# Round #1

## Response to review comments

Manuscript title: Flood risk assessment due to cyclone induced dike breaching on coastal areas of Bangladesh

Manuscript Id: NHESS-2018-169

Figure 1: Methodological approach followed in this study.

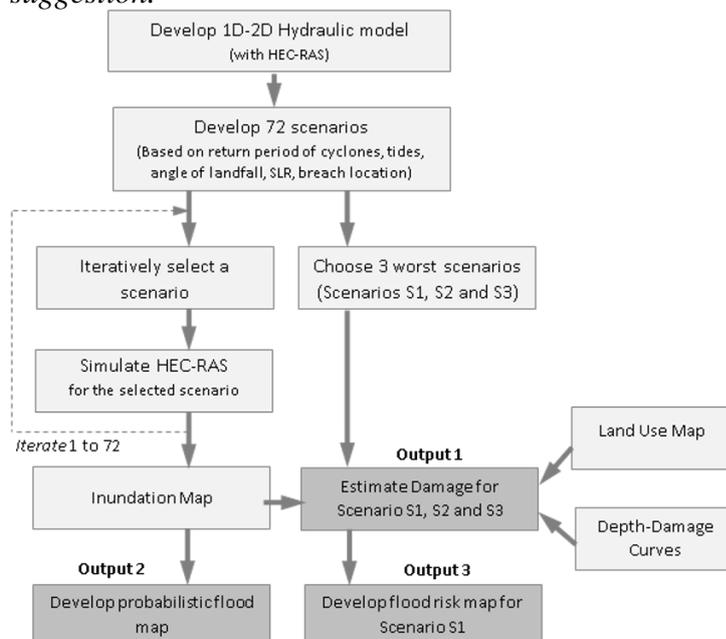
**Comment** [Methodology, part 1]: The first is the differentiation between the 3 extreme scenarios the 72 scenarios. I previously suggested that a different name be given for these sets of scenarios, but this was not done, and it requires careful analysis for the reader to dissect this for themselves. The flowchart helps a little but it also causes more questions, which are listed in the specific comments below.

**Reply:** *The authors apologise for not incorporating this suggestion in the previously revised manuscript. Figure 2 (shown below as well) has been updated now to incorporate this suggestion.*

*It may be noted that the scenarios have been named as S1, S2 and S3. Subsequent discussion in the manuscript (for example, P 11, L9) have been modified to include the names of these three scenarios.*

Figure 2: Schematic diagram of the study area with location of control structures and gauges and the considered breach locations.

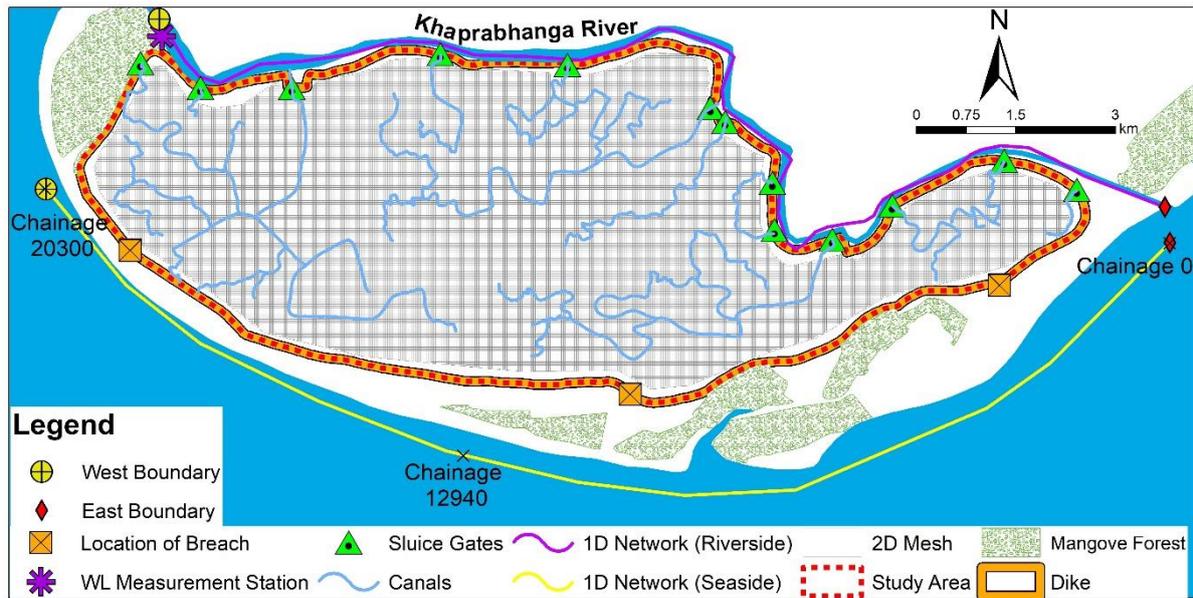
**Comment:** P4, figure 1: Please plot the extent of the dike on this map or on figure 3, as you mention it is only on the seaward side. Including the chainage points given in Figure 6 would also be useful.

**Reply:** *Thank you for the suggestion. As stated earlier in the section, study area (polder 48) is surrounded by dikes, the line denoting the study area also denotes the alignment of the dikes. This information is added to the manuscript to increase clarity. Chainage points and the extent of the dike for the area are added in the figure 3 (shown below as well).*

Figure 12: Flood risk map corresponding to the dike breach at the critical location of the dike. The following three classes of risk are shown: high, medium and low. The considered four landuses are shown as well.

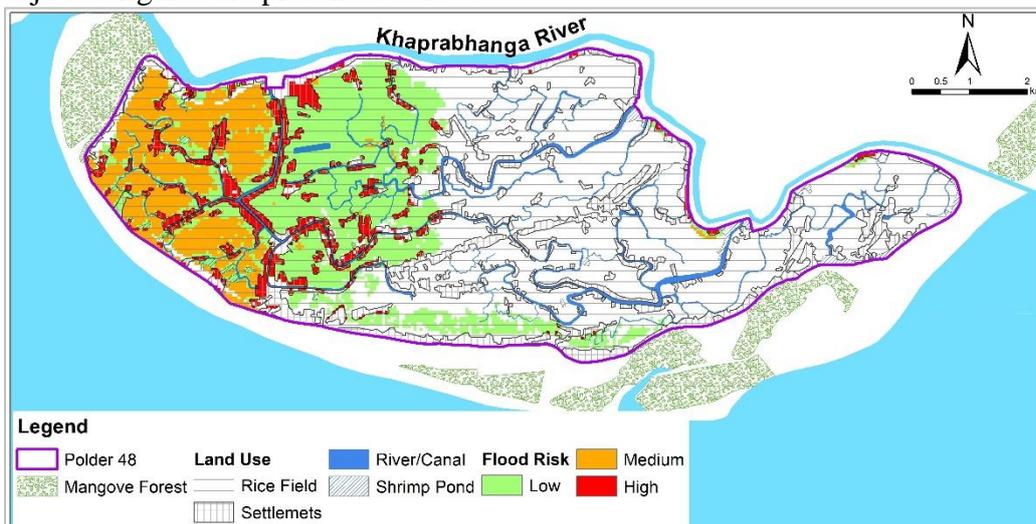
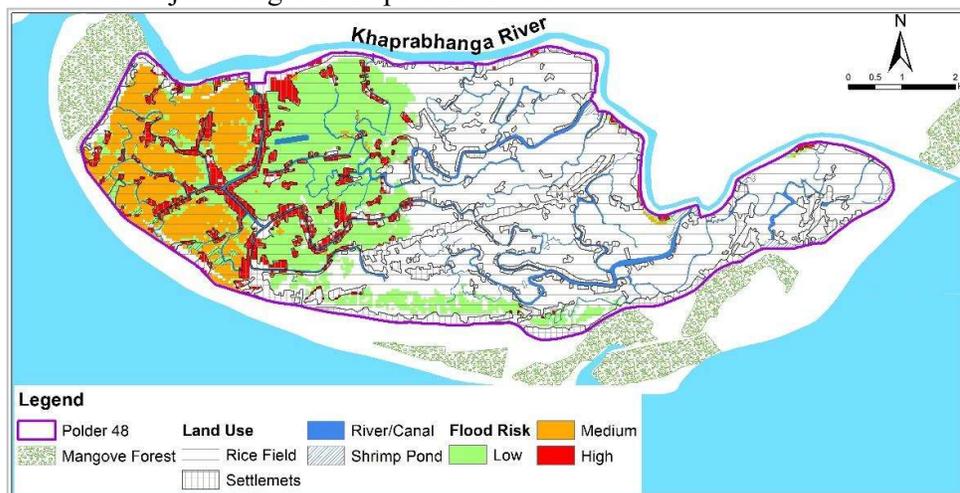
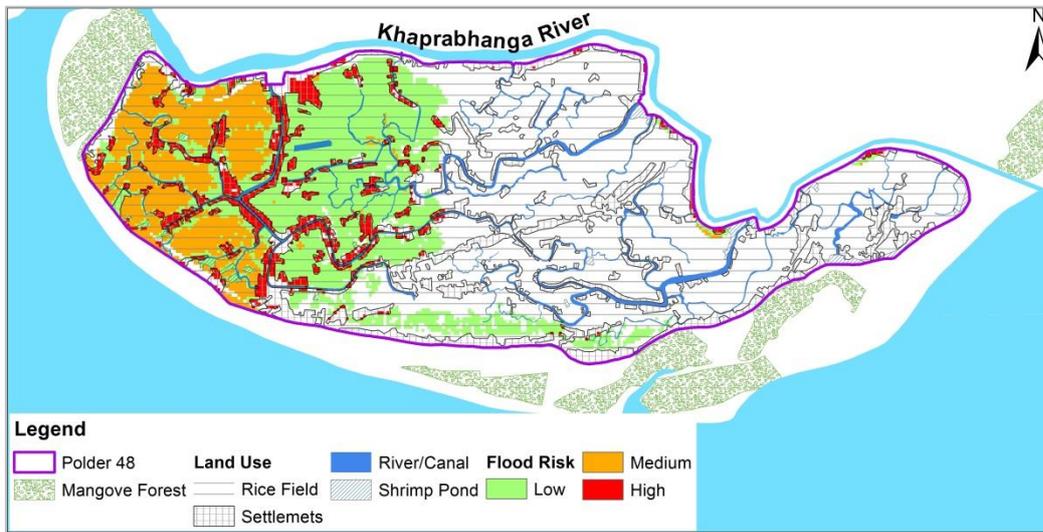
**Comment:** P18, line 3: Section 4.5 describes how the western breach was selected as the critical location, but you should mention that result here, as the flood map is clearly dependent on that. Perhaps it should also be plotted in figure 12 as well.

Figure 12 and 13 miss a scale bar.

**Reply:** Authors acknowledge the suggestion and the figures were adjusted accordingly. The adjusted figures are presented below:

Figure 13: Probabilistic flood map of the study area. Varying colours indicate probabilities of obtaining flood depths more than 0.5m.

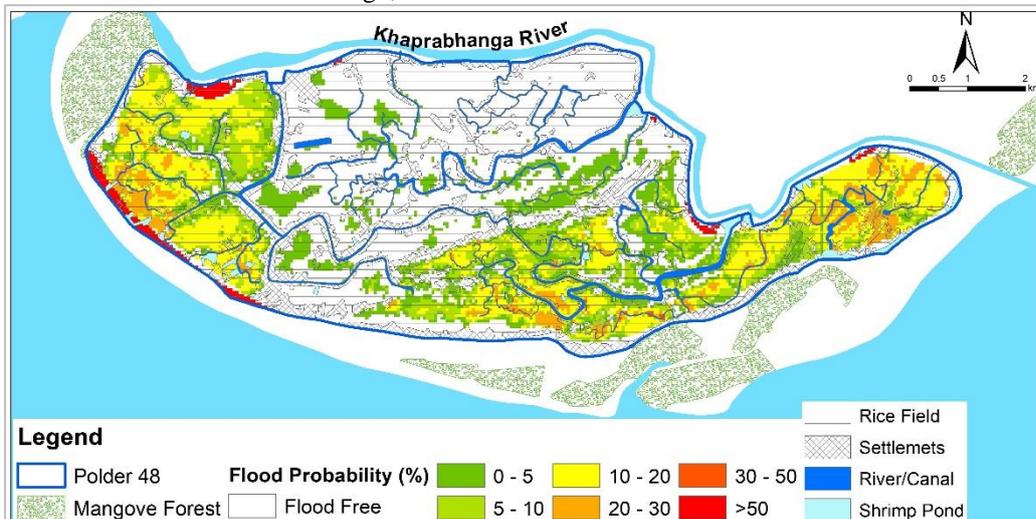
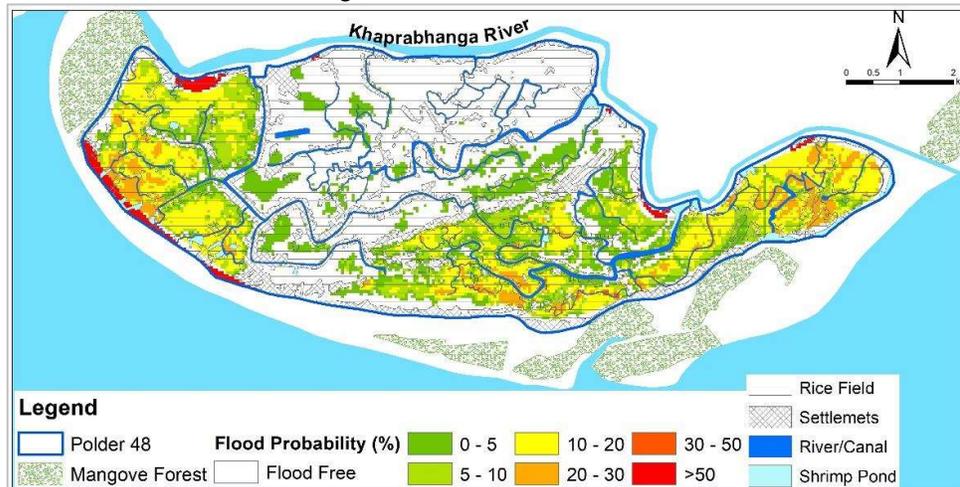
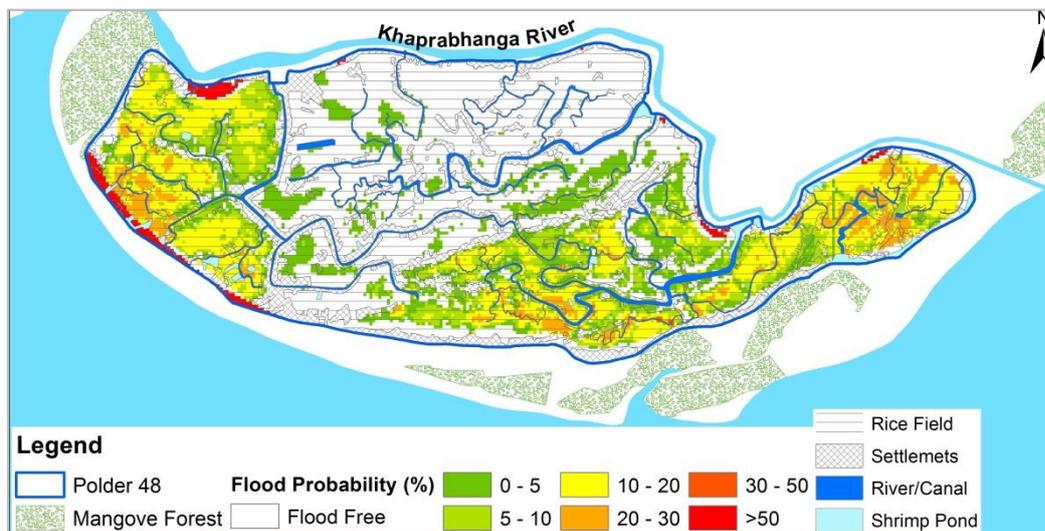
**Comment:** P20, figure 13: Again I think it should be mentioned that this is the 1/25yr PFM.

Figure 1: Location map of the study area Polder 48 (Kuakata).

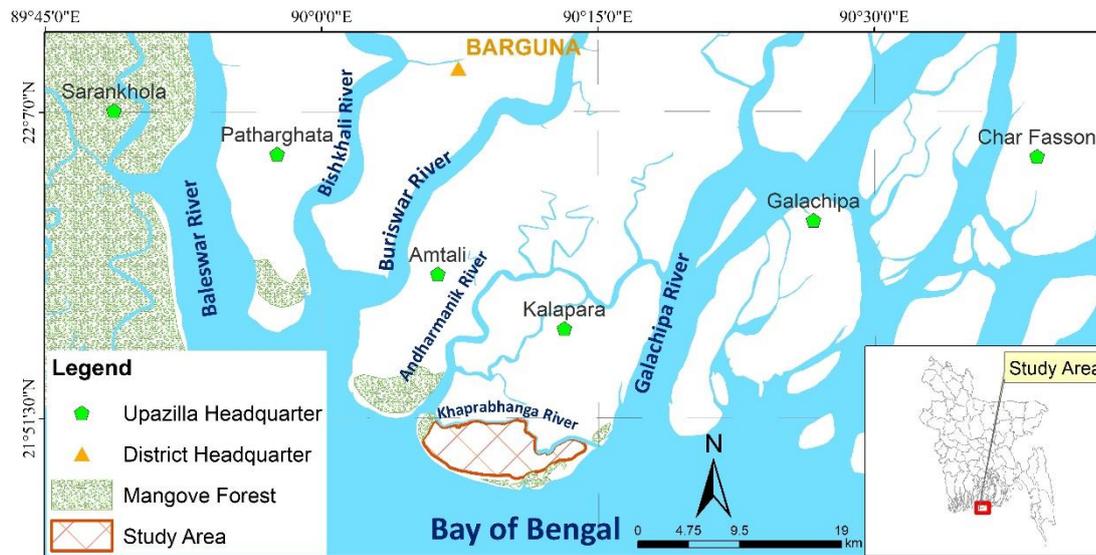
“P3, Fig. 1: Upazilla term used in figure, but not explained in text. Presumably it is a form of district”

p.3 line 3. It is recommended to visualise coordinates in Figure 1.

*Authors: Coordinates were added in Figure 1 (figure 1).*

**Figure 2: Methodological approach followed in this study.**

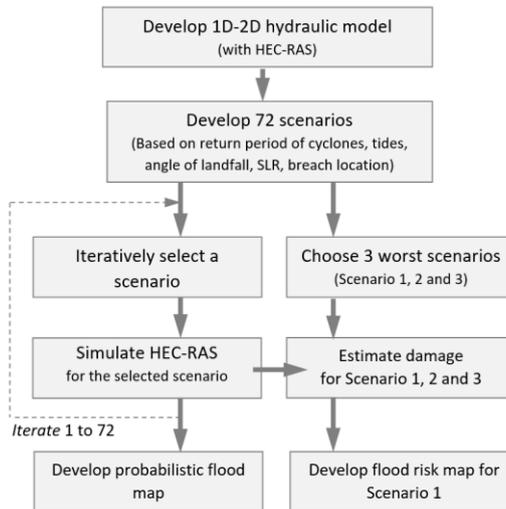
**Comment:** P5, figure 2: The arrow from HEC-RAS to ‘Estimate damage’ during a loop is confusing. The output of 72 simulations from the loop should be used.

**Comment:** P5, figure 2: Perhaps the damage and maps sections could be highlighted as outputs.

**Reply:** Authors thank the reviewer for the suggestion. The flow chart has been adjusted (Figure 2, page 5).

**Reply:** The flow chart has been adjusted following the suggestion indicating the estimated damage, probabilistic flood map and flood risk map as Output 1, 2 and 3 (Figure 2, page 5) respectively.

**Figure 3:** Schematic diagram of the study area with location of control structures and gauges and the considered breach locations.

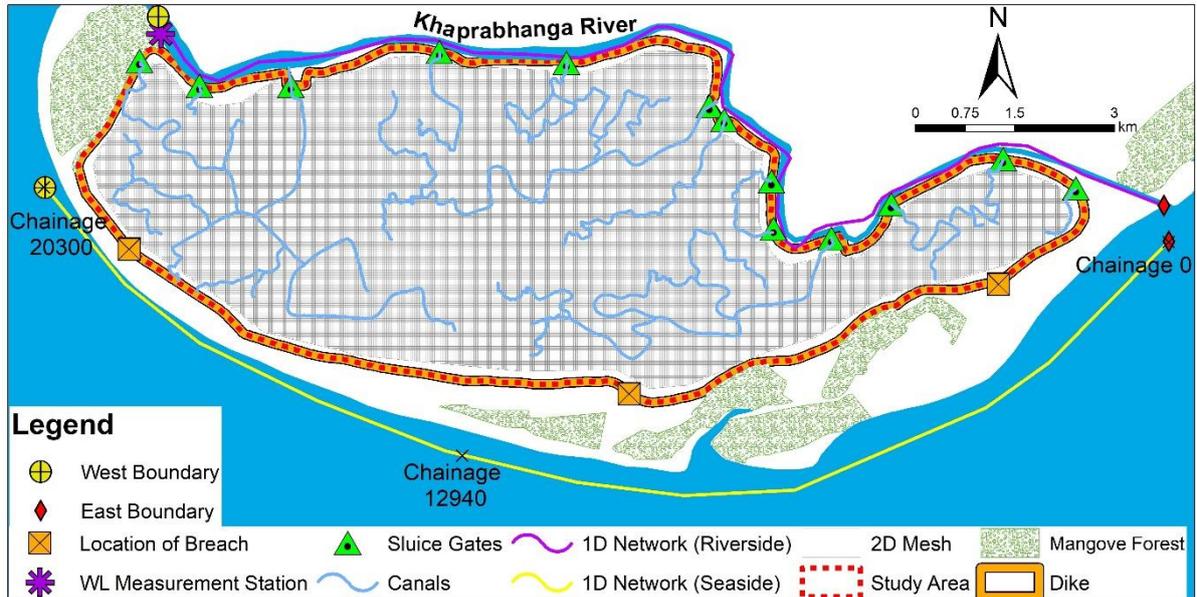
**Comment:** P7: Figure 3: Presumably Khaprabhanga is more of a channel than a river, as it seems to connect two parts of the Bay of Bengal. If this is the case it should be mentioned.

**Comment:** P7: Figure 3: How are the upstream and downstream locations selected? Presumably it is because it is assumed a cyclone always come from the west and therefore imposes a water level downstream, but this is never stated.

**Reply:** *Khaprabhanga River is connected to Galachipa River on the east and Andharmanik River on the west. This is shown in Fig. 1.*

*We have updated Fig 3 to show western and eastern boundary instead of upstream and downstream boundary.*

**Figure 6: Variation of water level at three locations (chainage 0, 12940 and 20300) different chainage along the 1D channel network on the sea side according to a specific Scenario (out of 72 Scenario).**

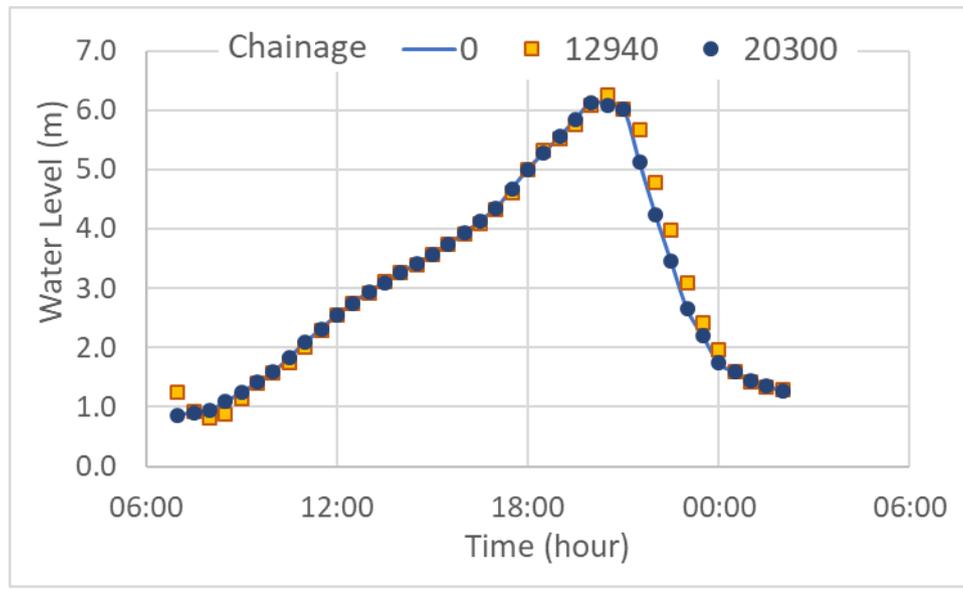
**Comment:** P9, figure 6: Why is the middle chainage higher than the others during the rising limb? This raises more questions about the boundary conditions.

**Comment:** P22, line 24: This is the first mention of ‘synthetic water level time series’. It is clear from the bottom of figure 6 that they are present, but not how they were generated.

**Reply:** Thank you for the query. But the authors failed to identify significant difference in water levels at the three chainage presented in figure 6.

**Reply:** The water levels presented in Figure 6 are result of having synthetic water level time series at the boundaries of the model. Unfortunately, measured water level during a cyclone was not available. The time series boundary file with the storm surge height considered for the 72 scenarios were generated following the measured tidal water level pattern. The following was added to clarify:

Figure 7: Depth-damage curves for different land use classes.

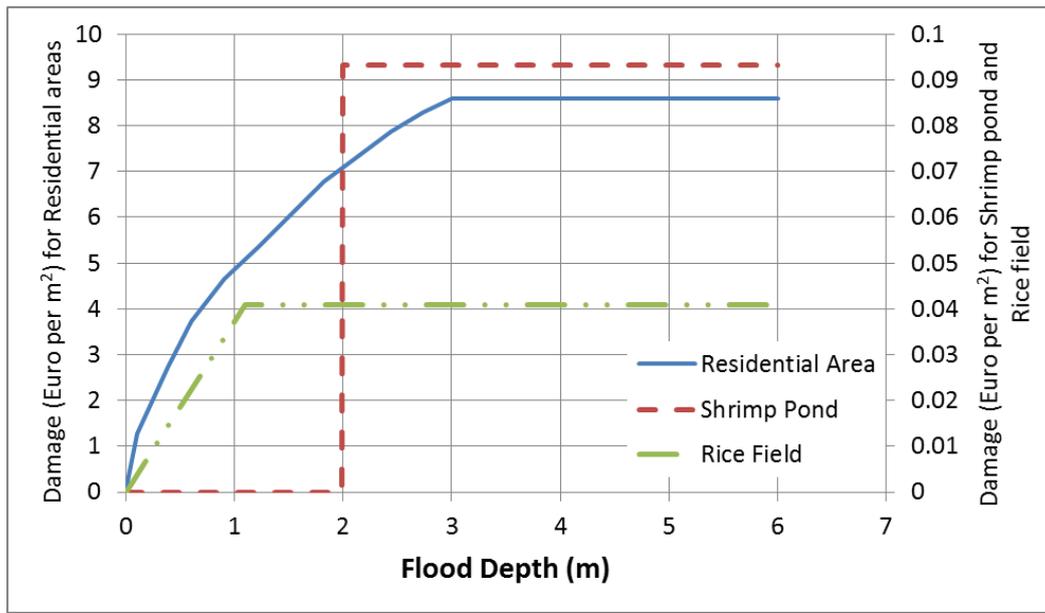
“P14, Figure 7: Can the authors explain why the damage decreases for larger flood depths?”

*The damage is a function of flood depth but the unit is per unit area (per m<sup>2</sup>). Therefore, if the flood extent for higher depth is lower, the damage due to flood might be lower too. It was explained in the revised version (on page 21, line 6 and 7).*

**Figure 9: Comparison of flooded areas corresponding to different Scenarios considering the breaching at central part of the sea facing dike.**

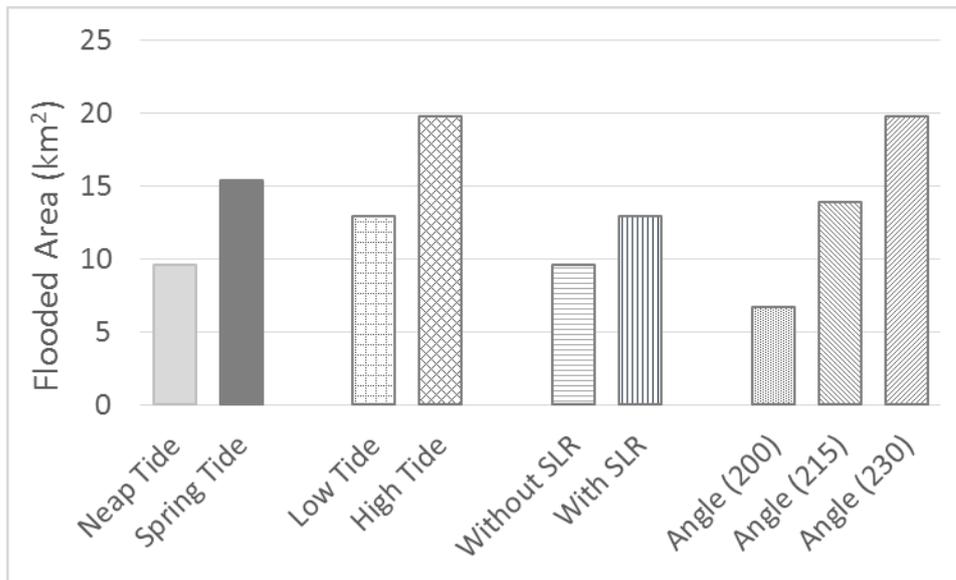
**Comment:** P16, figure 9: Presumably these figures are averages of subsets of the 72 simulations, This should be indicated in the text.

**Reply:** figure 9 represented the flood extents of different scenarios considering the breaching at central part of the sea facing dike. The title of the figure was adjusted as “Comparison of flooded areas corresponding to different Scenarios considering the breaching at central part of the sea facing dike.” to provide more clarity.

Figure 10: Flooded areas for different ranges of flood depths corresponding to different **Scenarios**.

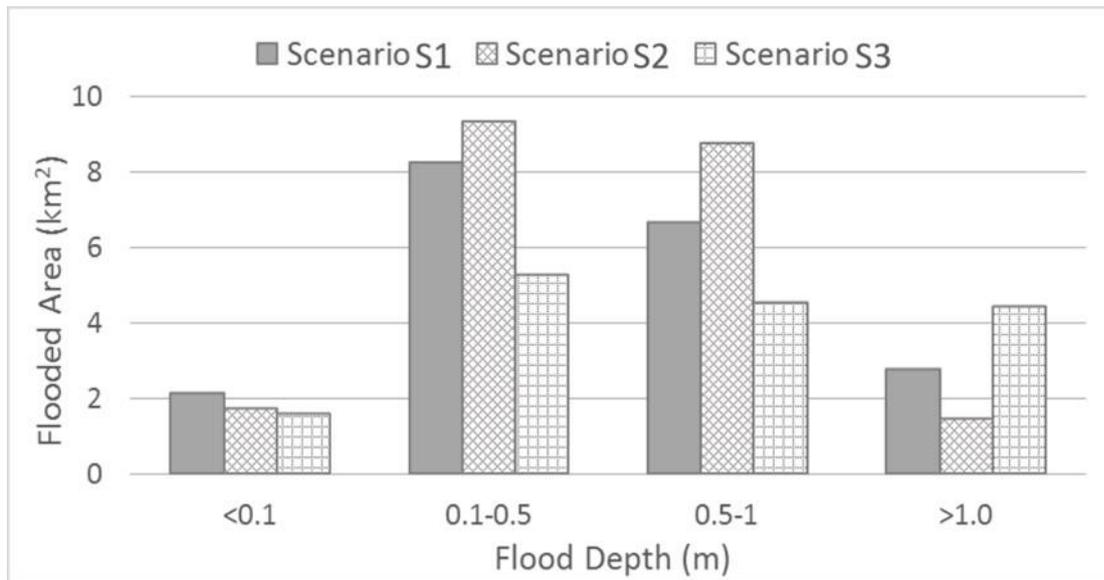
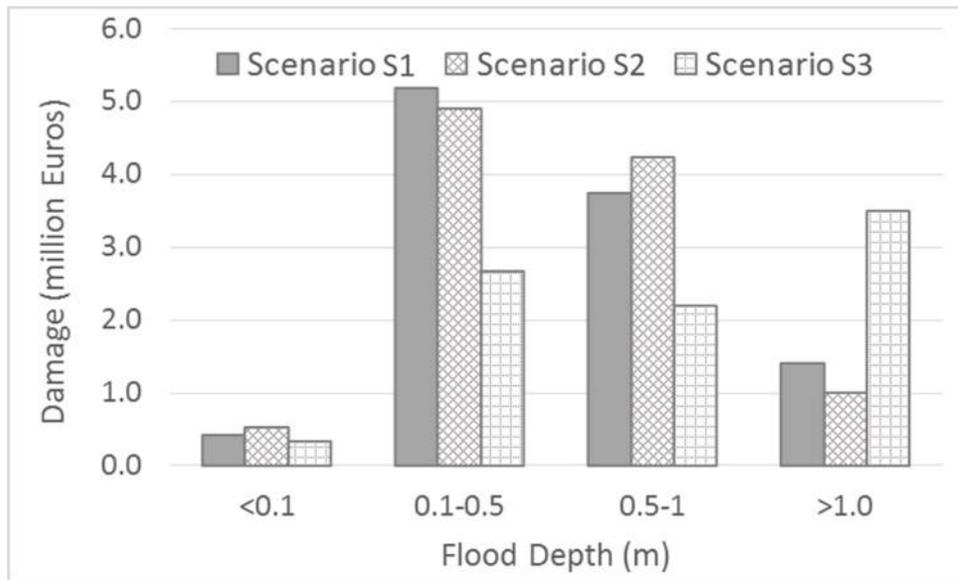
**Comment:** P18, figure 11: This figure and figure 10 need clarification. Can I infer from them that the area in which the maximum flood depth was less than 0.1m in scenario 1 (western breach) had an inundation of just above 2km<sup>2</sup>, which causes about 400,000 euros of damage? I see this is later explained in the discussion, but the authors might consider a clearer explanation at this point too.

“Figure 10 and Figure 11 corresponds to the flooded area and damage due to different range of inundation depth respectively. The flood area and damage was highest for the inundation depth of 0.5 m to 1.0 m.”
